The Friends of the Forster Country

TO ZAYD AL JAWAD SBC ASSISTANT DIRECTOR PLANNING & REGULATION COMMENTS ON PLANNING APPLICATIONS

OBJECTIONS TO 22/00781/RMM - Country Park.

Extract from developer's proposal

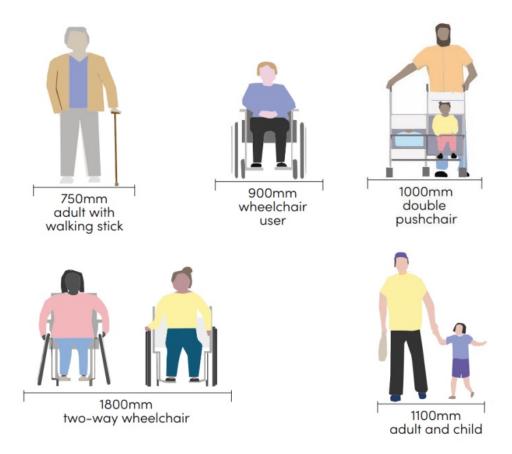
The latest proposal from Bellway Miller proposes the development of 3.5 meter wide self binding gravel multi use path. This is, to all intents and purposes, a **road that will run around the park**. This is proposed in a conservation area! Adjacent to Grade 1 and 2 listed buildings! And is wider than Weston Road!

There is no transport need for the cycle superhighway. We have met with the County Council's highways team and their requirement for a cycle path is only for a simple east west route through the fields. This can be accommodated, without the need for the circular road meaning a much less intrusive approach.²

By the developers own admission, the appropriate width for an accessible path is **1.8 meters**. Made from crushed gravel. This is what is in place at Great Ashby Park.

Except for the east-west cycle route, and the existing bridle way, there is no need for any path to be wider than 1.8 meters and so, in our view, this should become the default width.

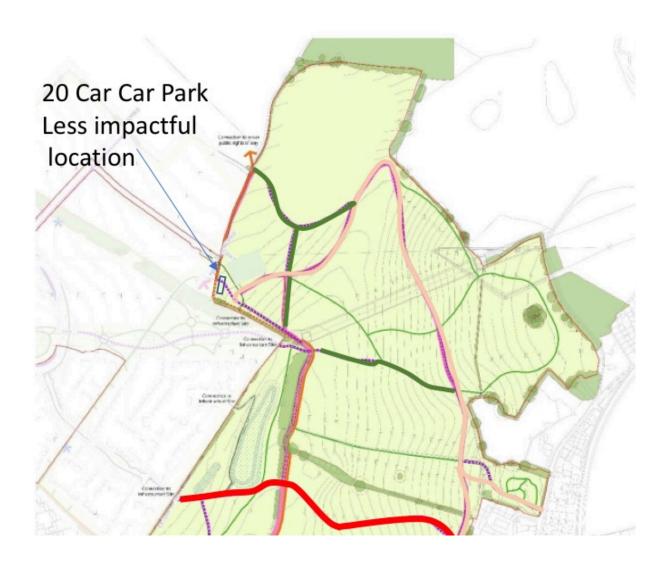
2.1 A new multi-use car park adjacent to St Nicholas Church This proposal has come forward with the full support of St Nics Church. Indeed, the Church is in advanced conversations with the landowner to purchase the land in question and use their own resources to convert it into a car park. This would see additional car parking being made available to visitors of the meadows in a period similar to that being brought forward by Bellway Miller for their car park. The land is in the ownership of the same land-owner Bellway Miller has purchased the meadows from. Indeed, over a year ago, Bellway Miller promised a meeting of FOFC, officers of the Council and the relevant Cabinet Member (Cllr Speller) that they would approach the landowner to see whether they could incorporate the land into their proposal. A year on and they have not followed through on that promise, they have not contacted the landowner and no progress has been made.

The new car park could be used by visitors to the church, cemetery, and meadows. It would draw visitors to the heart to Forster country. It could also be used as overspill for major church events and by parents at school pick up time.

We strongly urge the Committee to reject the car park idea, until this option has been carefully considered by the developer and the Council.

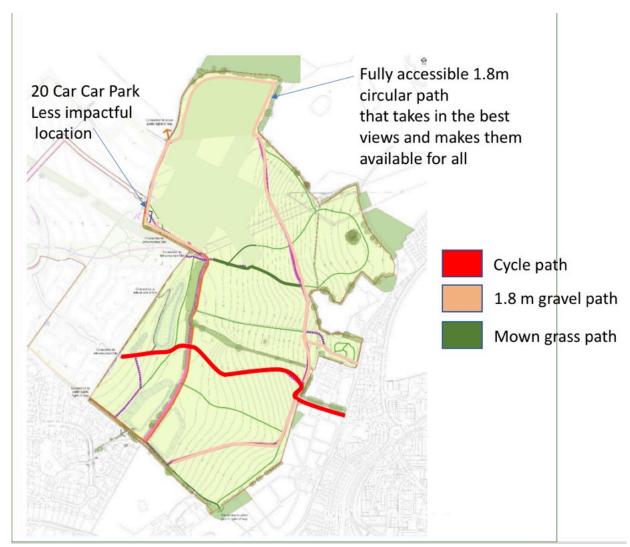
We find it deeply disappointing that Bellway Miller are persisting with this outrageous proposal. If agreed, the dumping of spoil, will, forever alter the topography of the landscape as it would have been known to EM Forster. It causes unnecessary harm to an area that is already beautifully contoured and one of the most attractive parts of the conservation area for no apparent benefit other than it makes lighter work for the developer and saves them money.

By rejecting the mound, the planning committee can open the prospect of the northern part of the meadows to becoming publicly accessible. The views from the northern part of the meadows are stunning. Routing paths this way would also ensure maximum use of the paths/bridle way that are already there rather than putting more development on the fields. This would reduce the need for the multiple paths around the car park, and the additional developed paths criss-crossing the open fields. What a shame Bellway Miller chose not to consult us and instead put forward their plans using only a desk top exercise. We have known these fields for decades and know

As shown above we propose looping what we would like to see as the 1.8m gravel path up to the north of the fields rather than cutting across them, before linking into the existing bridle way.

Figure 6 extract from Earth Works Assessment and

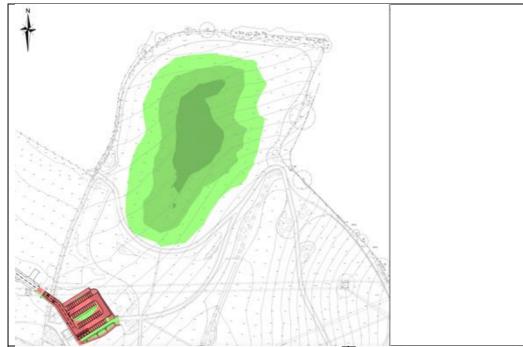
Moreover, the creation of the mound during phase 1, 2a and 2b of the 'Country Park' will cause significant and unnecessary harm to the conservation area during the construction period for the best part of a decade. This creates significant harm and is a material consideration for the Planning and Development Committee in their determination

Figure 7 extract from detailed reserve matter showing proximity of permanent hard development to Grade 1 listed Rooks Nest House and Grade 2 listed Rooks Nest Farm and Barns.

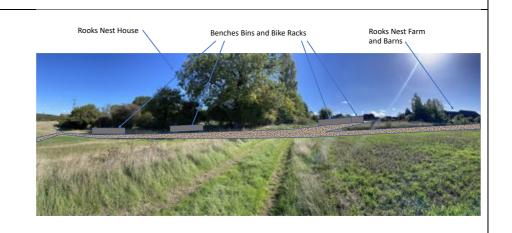
Figures 7 below reproduces the detailed proposals for the development of the 3.5 meter-wide multi-purpose path/road together with other installations (benches, bike racks etc.) and its juxtaposition with significant heritage assets. Implementing these proposals will have a permanent impact on the environment and character of the land immediately (a matter of feet) away from the Grade 1 listed Rooks Nest House and its grounds, and the Grade 2 list Rooks Nest Farm and Barns. There has been no heritage impact assessment of these proposals and seemingly no involvement of the Council's heritage teams in the development of them either, despite the fact that implementation will require excavation and land levelling and the removal of sections of ancient hedge-row.
